CERTIFICATE OF APPROPRIATENESS

Property: 1029 Arlington Street, Lot 4, Block 219, Houston Heights Subdivision. The property includes a historic 1,500 square foot, one-story wood frame single-family residence situated on a 6,600 square foot (50' x 132') interior lot.

Proposal: Alteration – Addition, Revision to COA approved by HAHC **5/22 HPO2022_0110**

Recommendation: Approval with conditions: Lower roof pitch and work with staff on final design.

North Elevation: Existing. C.2013 addition has already absorbed historic corner – not applicable
 South Elevation is inset **3'-11"** addition extends from previous non-original addition -not applicable

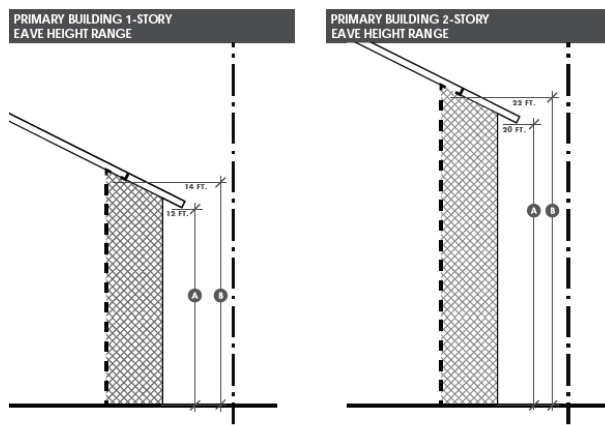
- North elevation has no inset as the side wall is 40 and there's a later addition to the original home.
- South elevation has an inset length of 6'-3 1/2" and an inset depth of 3'-1 1/2"

2 ORIGINAL NORTH (SIDE YARD) ELEVATION:
 WITH NEW ADDITION BEHIND ORIGINAL GABLE ROOF
 SCALE: 1/4" = 1'-0"

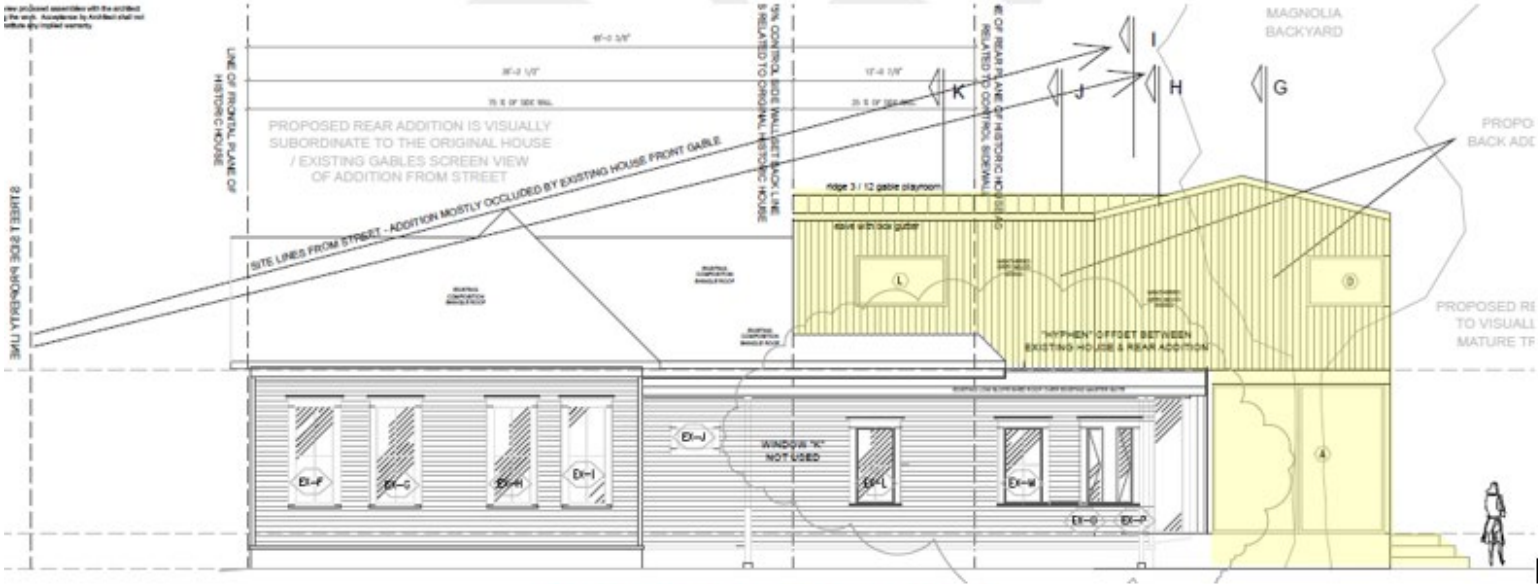
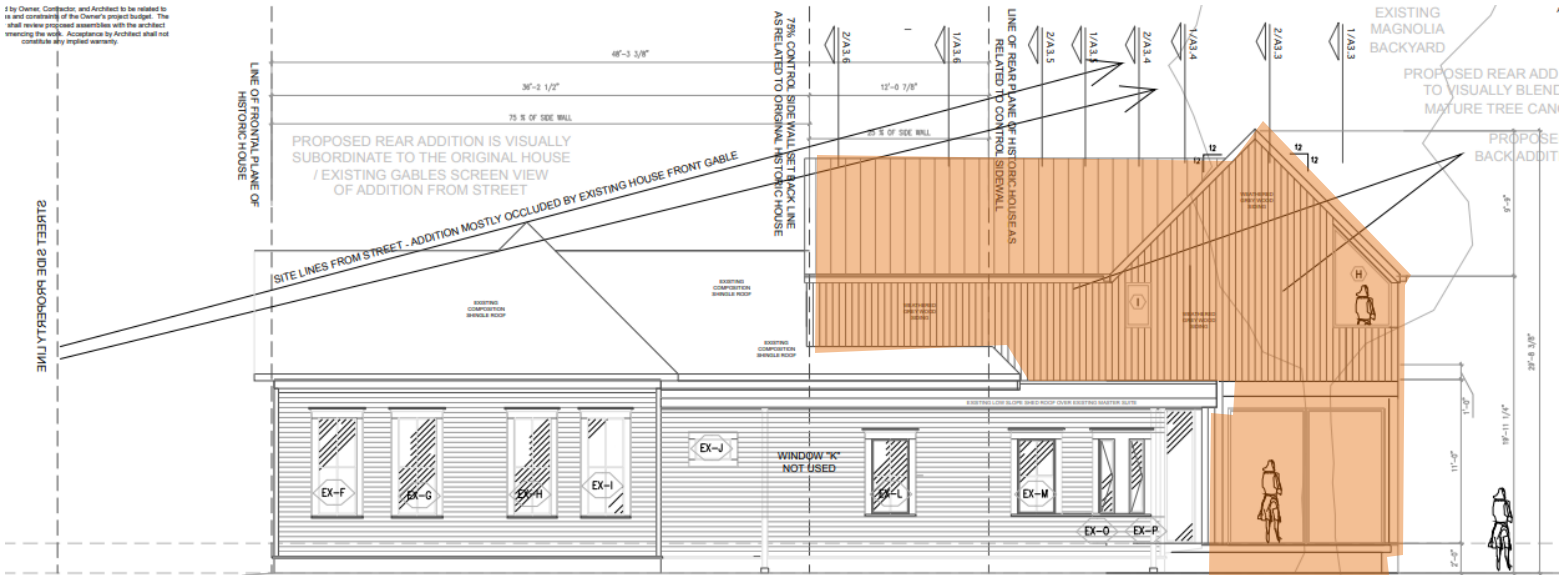
I have a graphic mistake on the north side: the two windows shown close together that you have highlighted = that is incorrect: there is only the one existing unit to the right, highlighted. The "original house" graphic is imported from the 2012 bathroom room project & in reality the builder for that project did NOT add that window in, which would have gone into the new master closet. So the graphic showing the addition is the one that actually has the correct graphic for the existing windows on that north wall.....

PROPOSED MODIFICATION TO APPROVED CERTIFICATE OF APPROPRIATENESS: LOWER SECOND FLOOR
 EAVE HEIGHT AND INCREASE NEW GABLE ROOFS TO 12:12 SLOPE TO MATCH EXISTING HOUSE

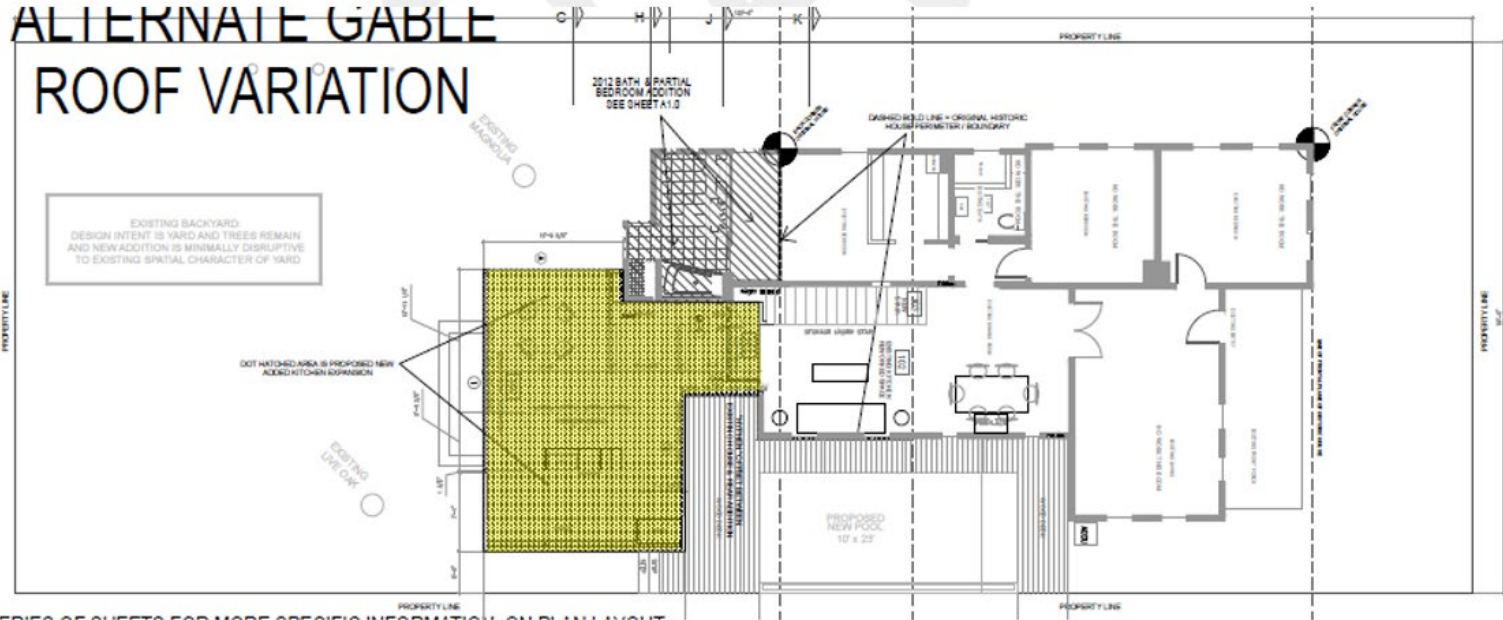
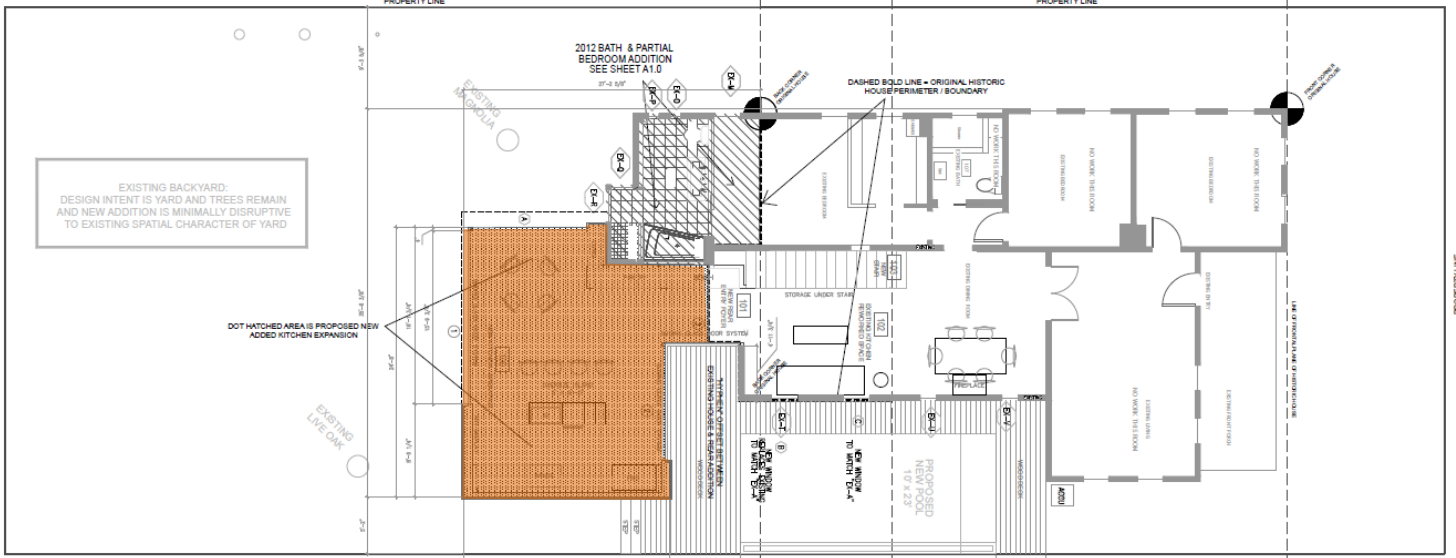
<i>Rear addition roof pitch is 12/12, while it matches the historic, it is not typical of additions on contributing buildings in the area and has a more pronounced form or profile. If the roof pitch was lowered, the addition would appear more recessive.</i> |

<i>Rear addition roof pitch is 12/12, while it matches the historic, it is not typical of additions on contributing buildings in the area and has a more pronounced massing and scale. If the roof pitch was lowered, the addition would appear more recessive.</i> |
